Municipal Planning Commission Meeting
Thursday, September 17, 2026 at **6:00 PM**

AGENDA

REPORT TO THE MUNICIPAL PLANNING COMMISSION

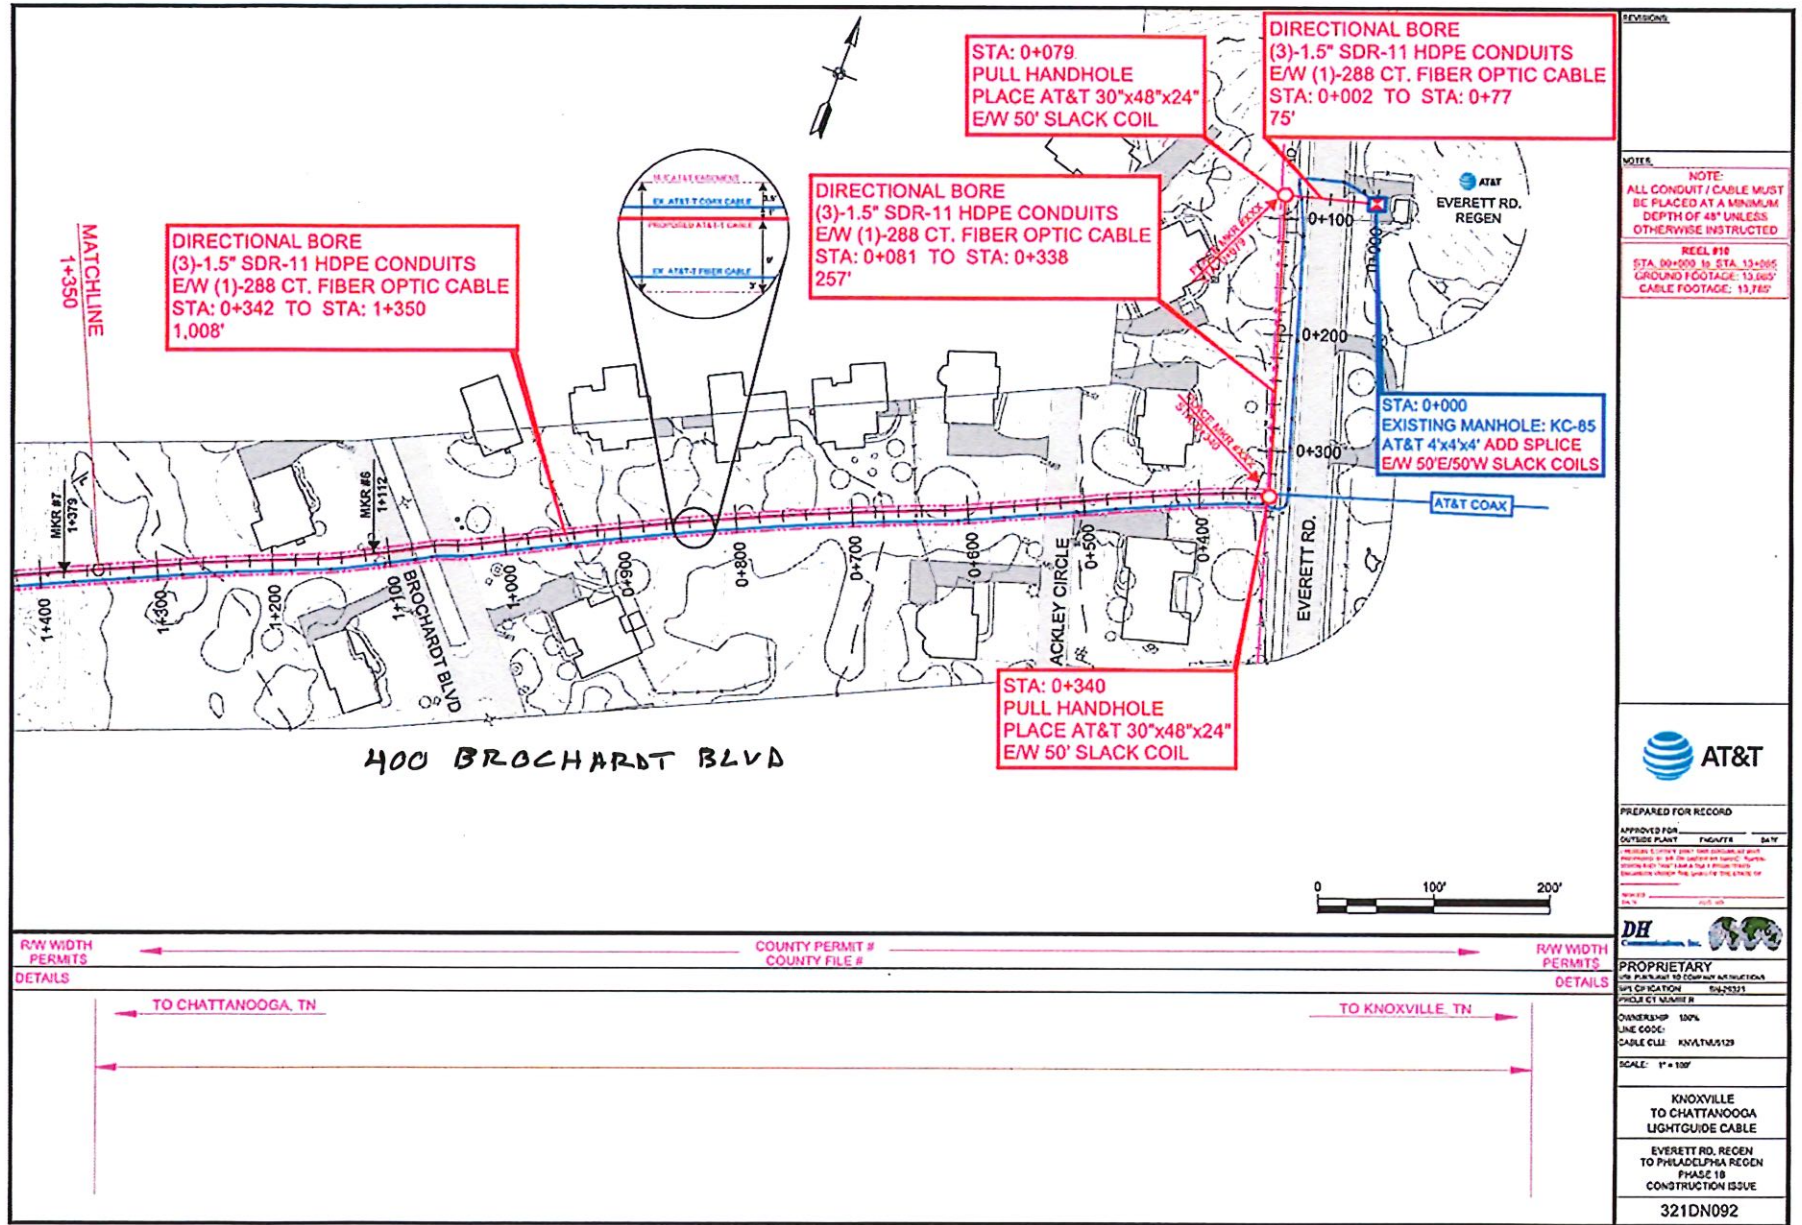
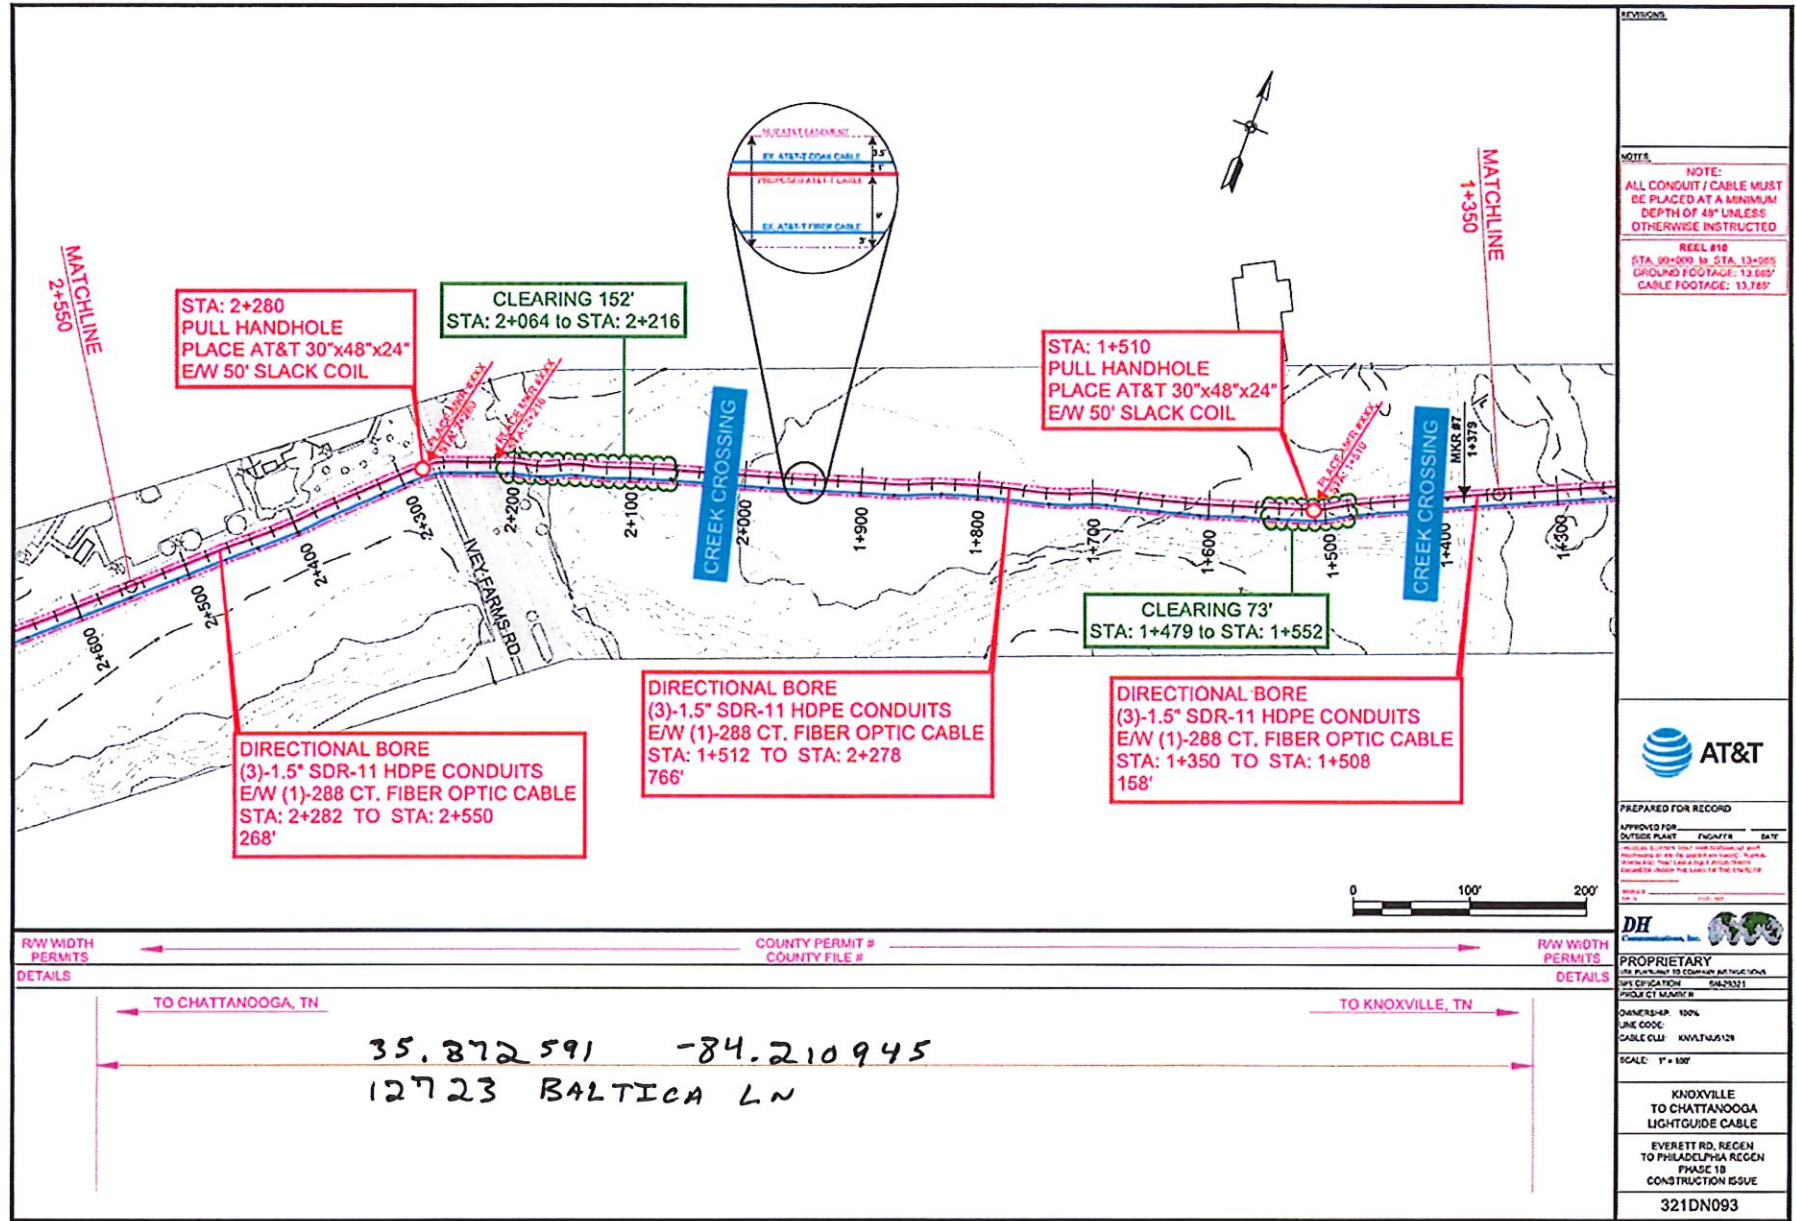
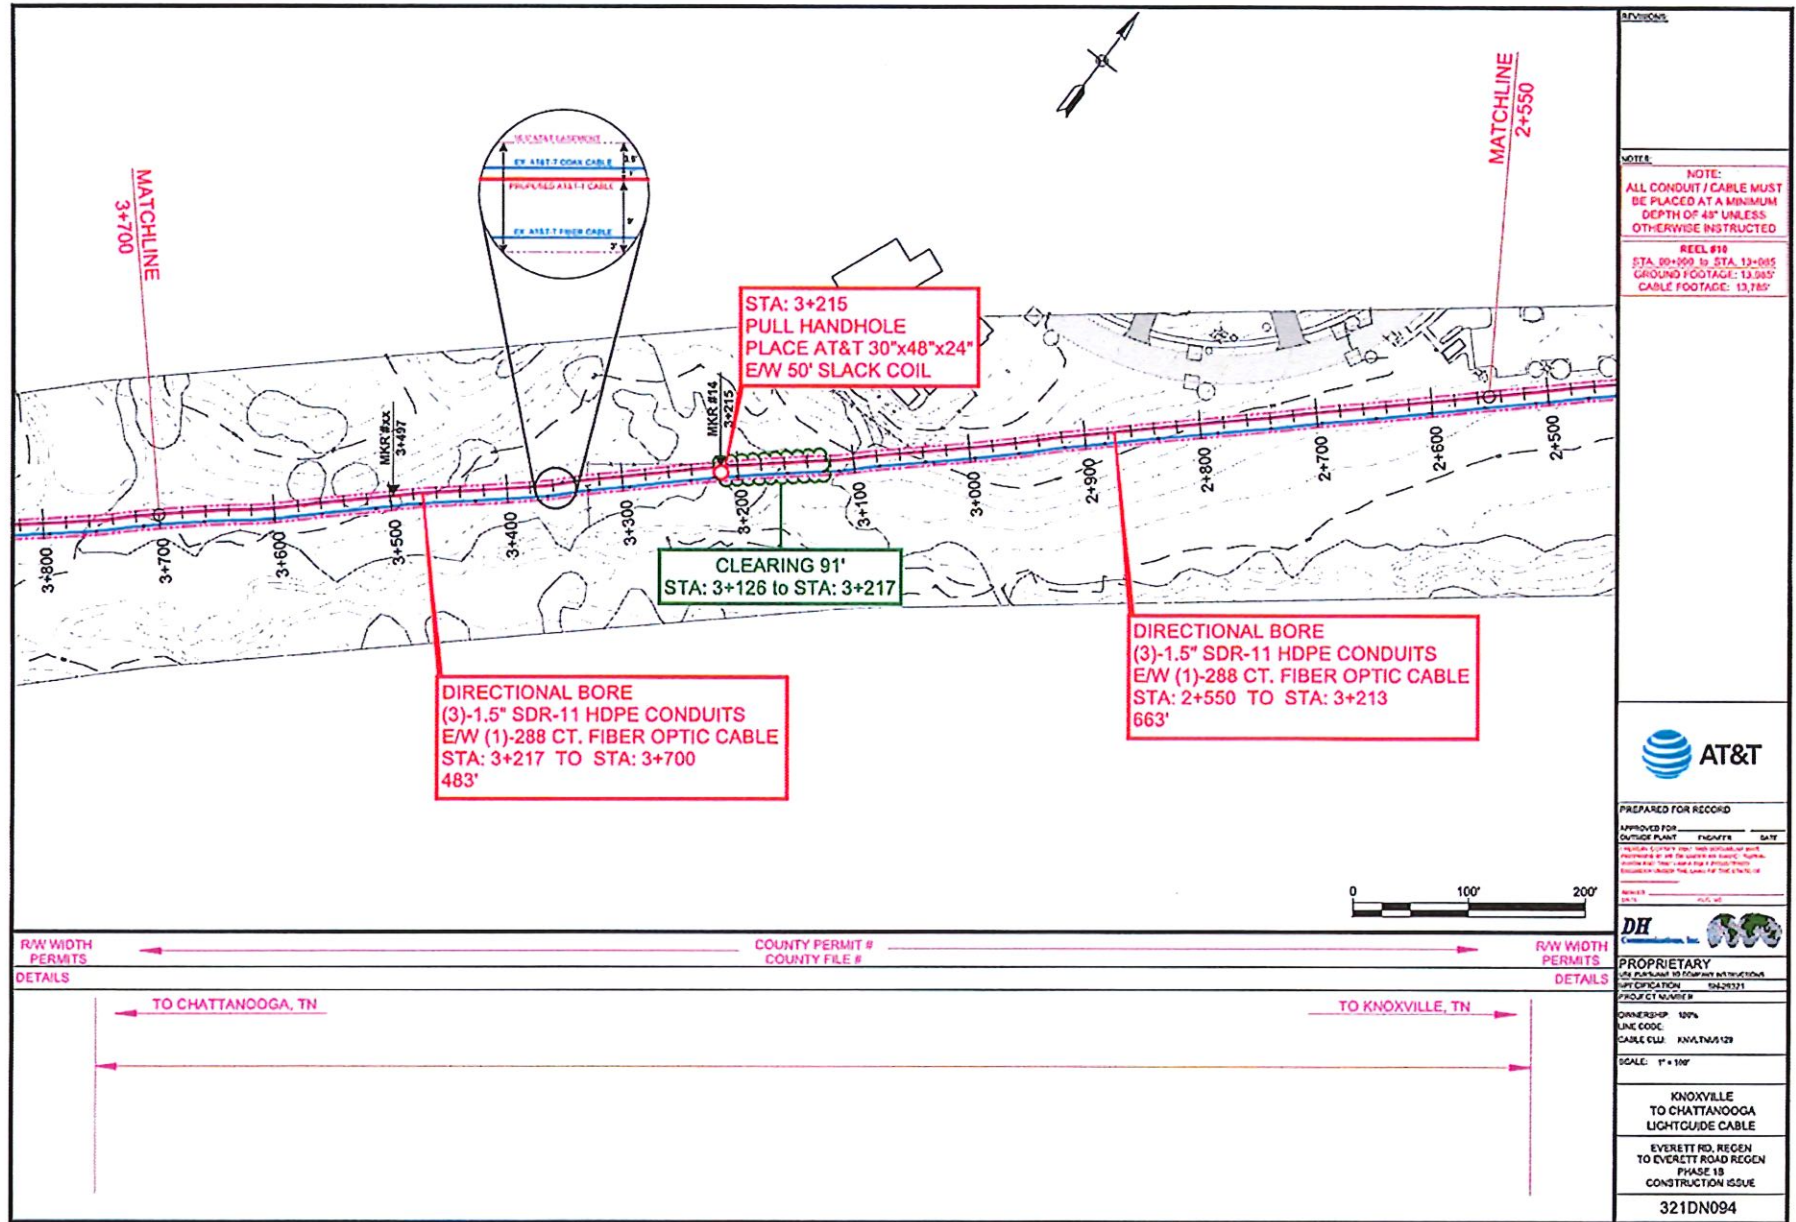
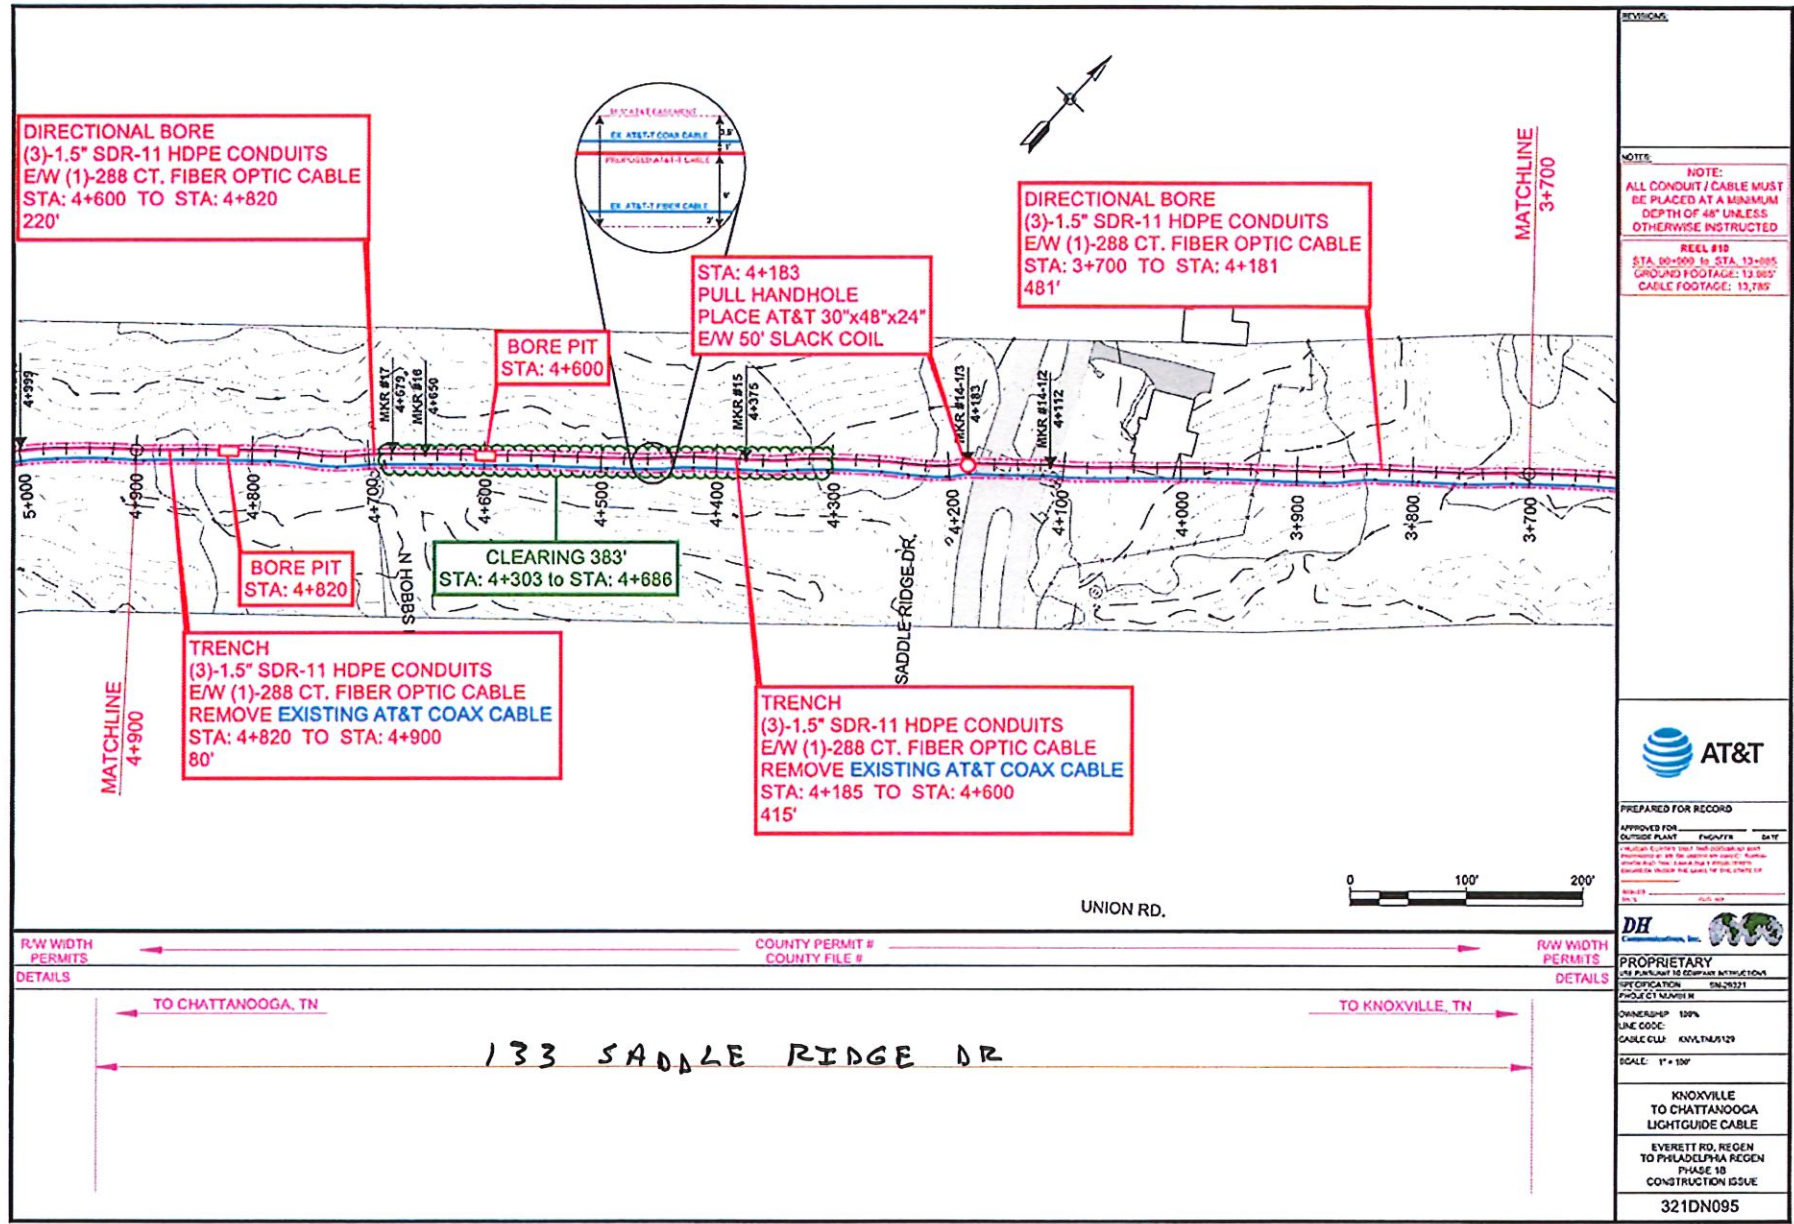
Discussion & Recommendations: Some reference to trenching is still on the plans and, as discussed with the Town's Engineering staff, this will need to be changed to note that all work will be using directional boring. This has been discussed with the applicant and they will be adjusting the plans.

Proposed Motion: The staff has reviewed the plans and is recommending approval subject to removing any reference to trenching and obtaining a right of way permit from the Town's Engineering Department. This will ensure that the installation is coordinated with the Town. The applicant's installer has a performance bond with the Town to also ensure that any affected areas are restored to their pre-construction condition.
